**RE: 9 Barnard Rd. Section 108.03, Block 3, Lot 54
GENTILE
Continuation Of Planning Board Site Plan Review**

**Re: 9 Barnard Rd. / Section 108.03 – Block 3 – Lot 54
Continuation for Planning Board Site Development Plan Approval**

This letter accompanies a continuation for Planning Board site plan review for proposed legalization of improvements of the property at 9 Barnard Rd. Additional information has been provided as the result of the Planning Board site visit and Consulting Engineer review.

SITE PLAN
SHED ADDITION AND
STONE RETAINING WALL
PROPOSED CONDITIONS

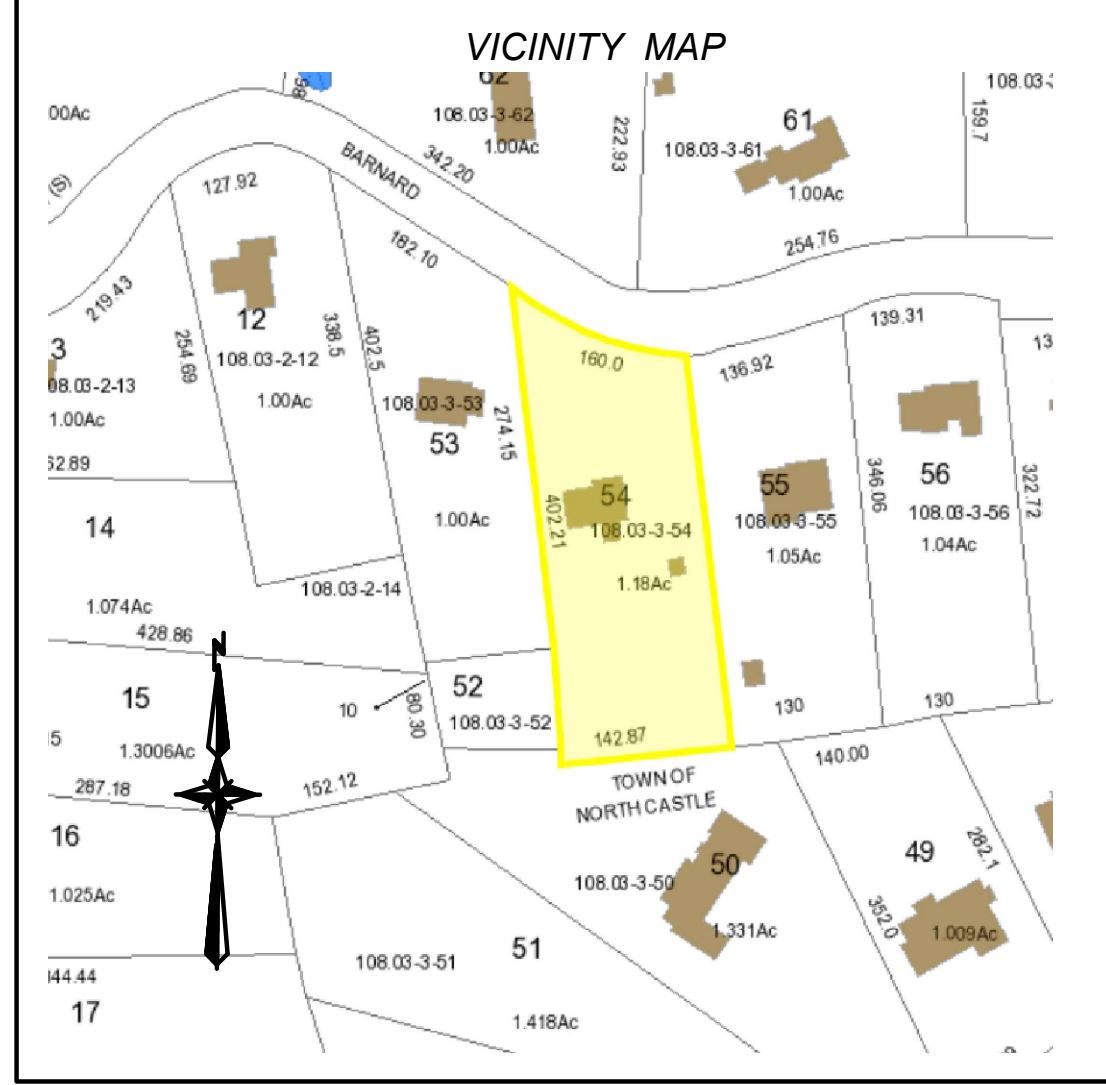
8. Drawing S-2 appears to have been named incorrectly and should be revised to "Proposed Conditions".

Drawing S-2 has been revised to "Proposed Conditions"

SITE PLAN SHED ADDITION AND STONE RETAINING WALL DETAIL SHEET

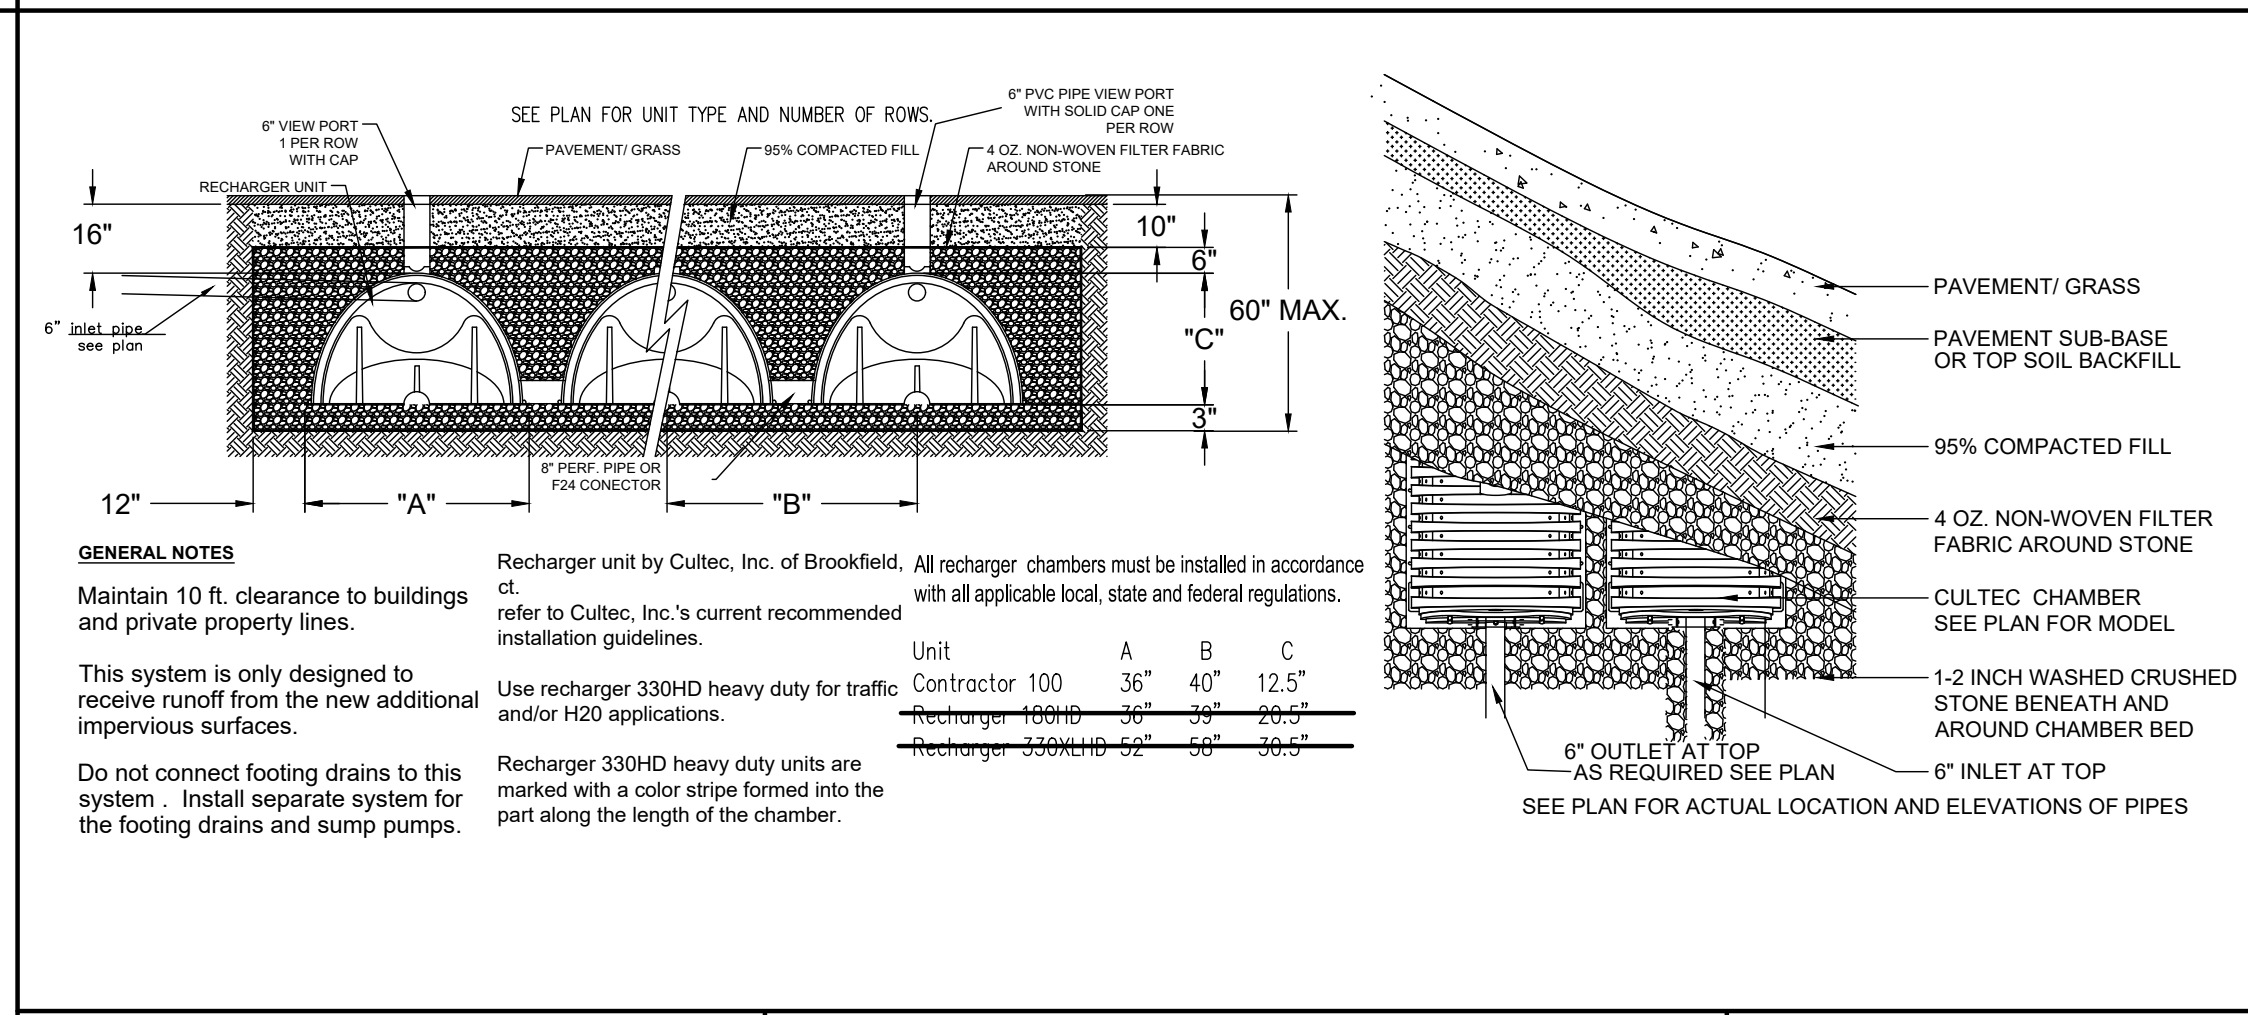
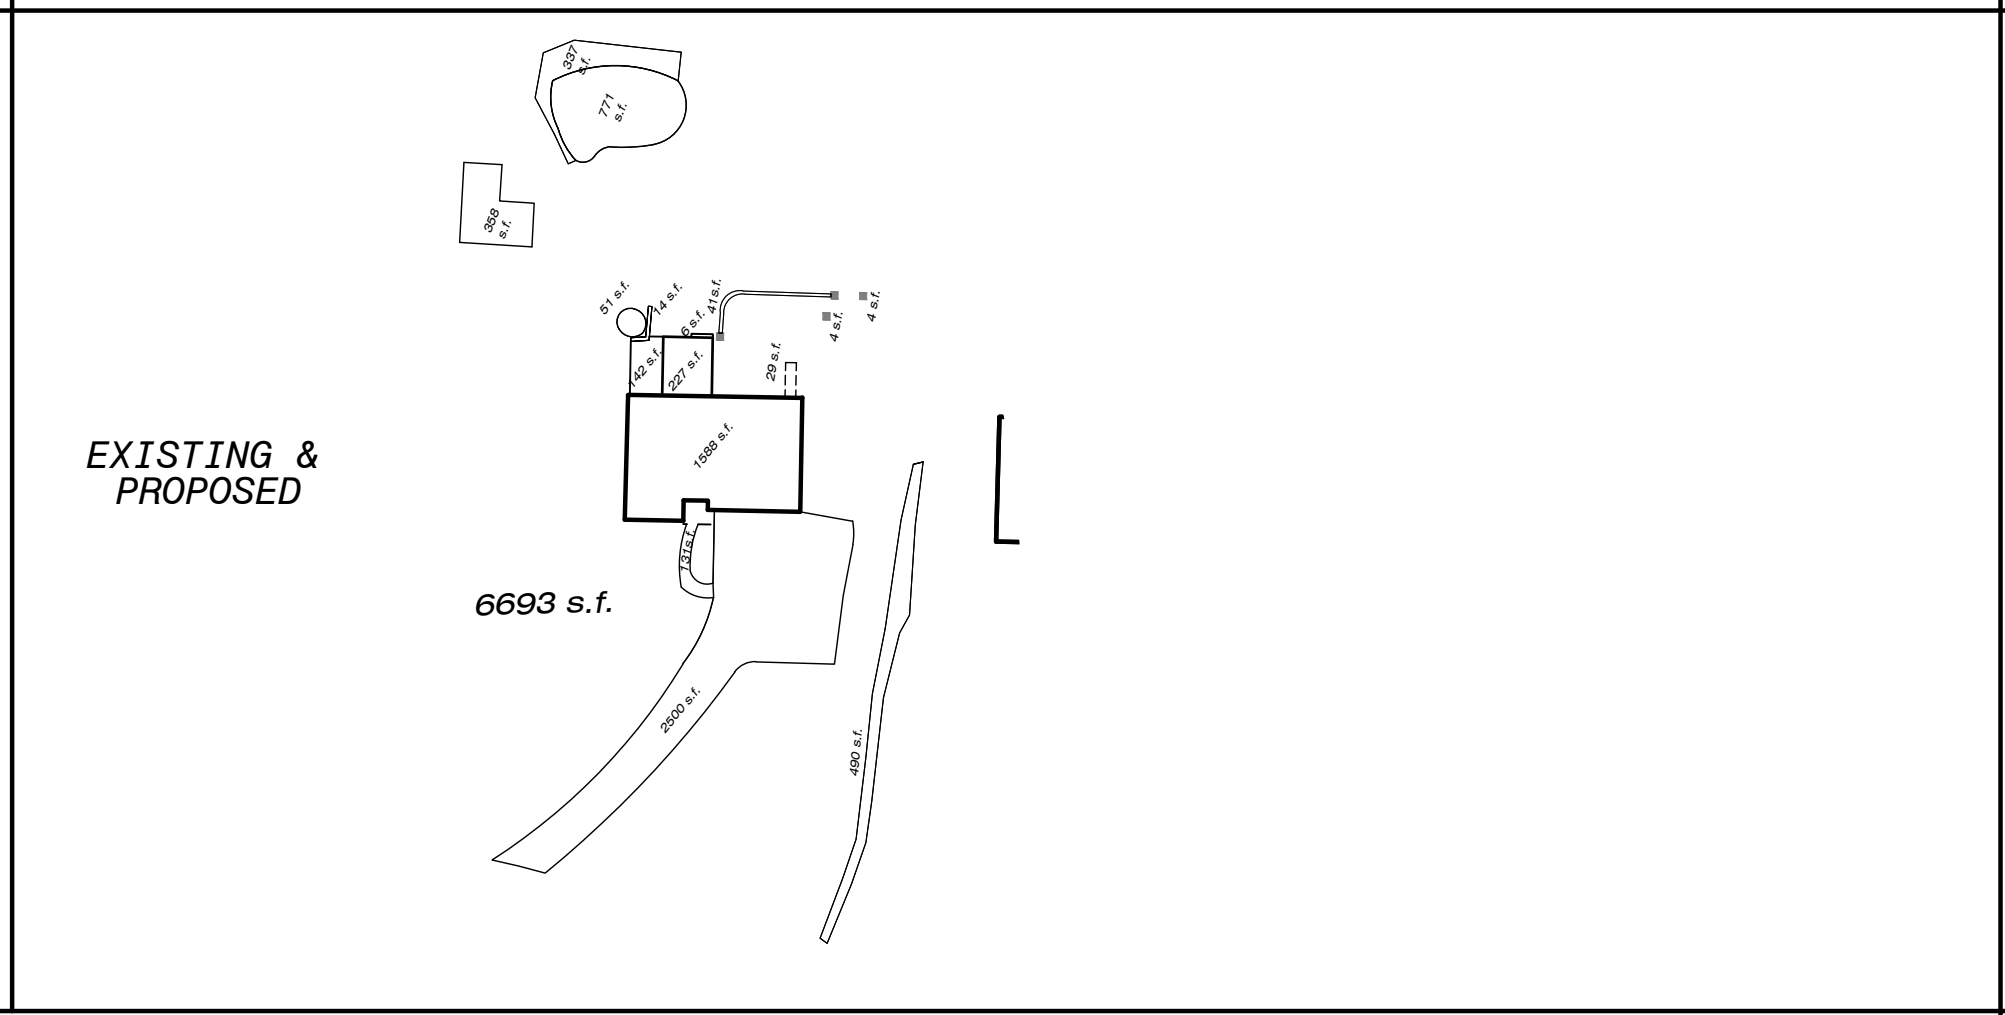
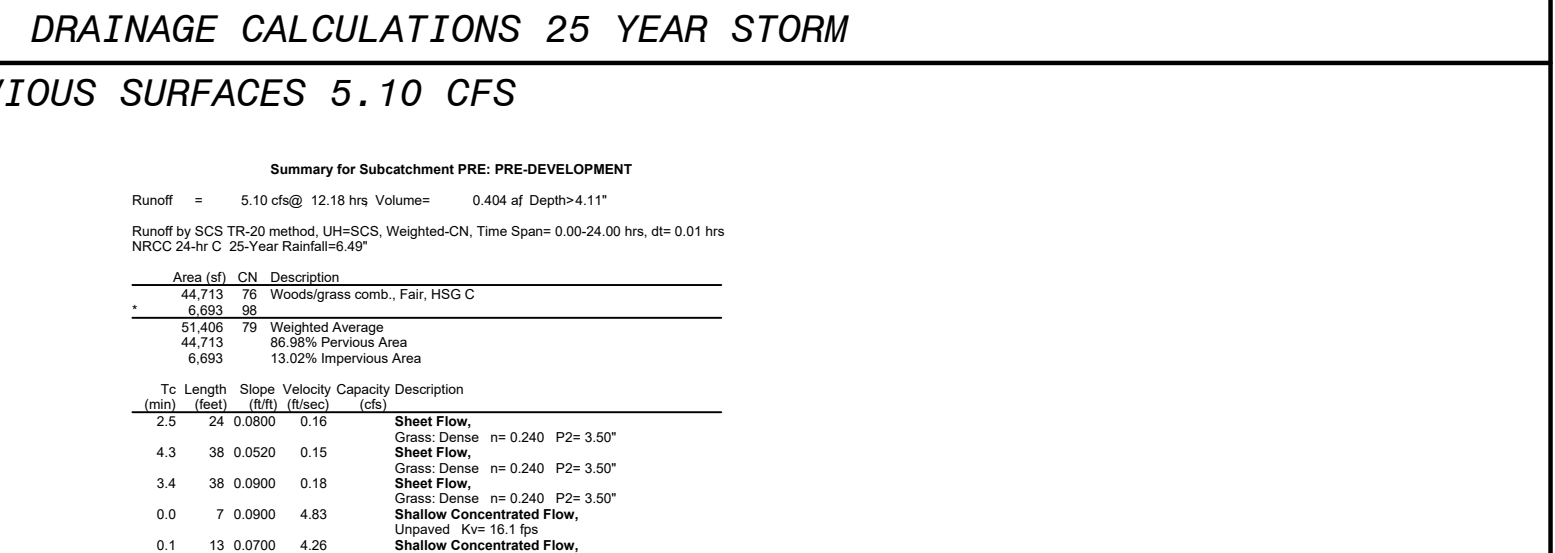
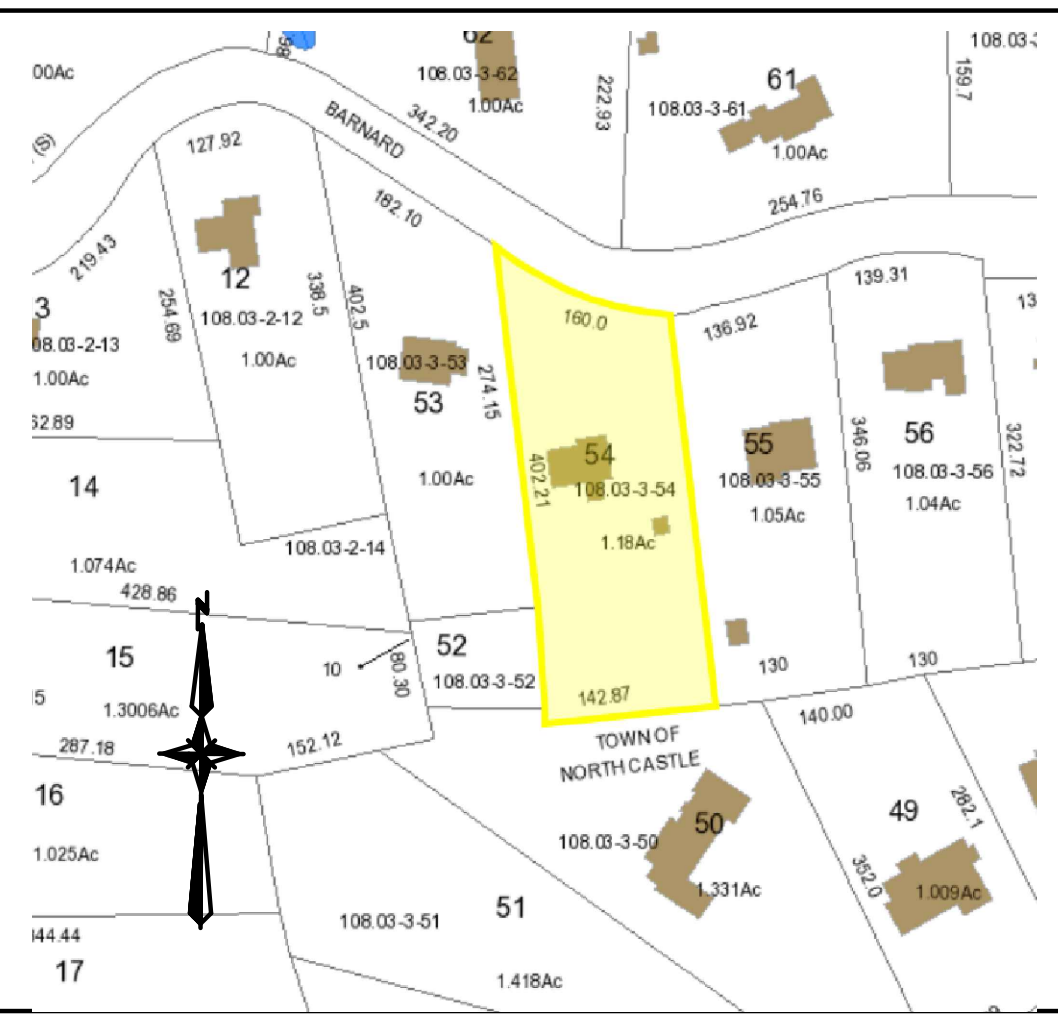
- The Stone Wall Detail illustrates a tiered retaining wall with a maximum height of four (4) feet. The existing retaining wall is not dimensioned on the detail. However, based on field visits, the wall reaches heights of approximately eight (8) feet. The lower tiered wall does not dimension the footing width or depth of crushed stone backfill. The retaining wall design and detail shall be updated accordingly. When the original wall was first constructed, and as part of the prior application, the applicant was required to provide a design certification by a New York State Licensed Professional Engineer demonstrating that the wall, as constructed, is stable, has been adequately sized to provide appropriate factors of safety for sliding, overturning and bearing, and has been constructed in accordance with the design and detail. Said certification was not received by this office. It is not clear why the lower retaining wall is required or being proposed at this time. We assume that the plan to construct a second tier with a maximum height of four (4) feet is to eliminate the need to provide the above certification. However, the proposed retaining wall plan will require clearing of whatever vegetated buffer remains along the property line. The Planning Board should consider whether this is appropriate or if the wall should remain as is and the certification be provided.

The construction of the lower wall is no longer under consideration. It was suggested at the Planning Board site visit that the existing wall will remain. A letter of certification to the construction and stability has been provided with this submission.
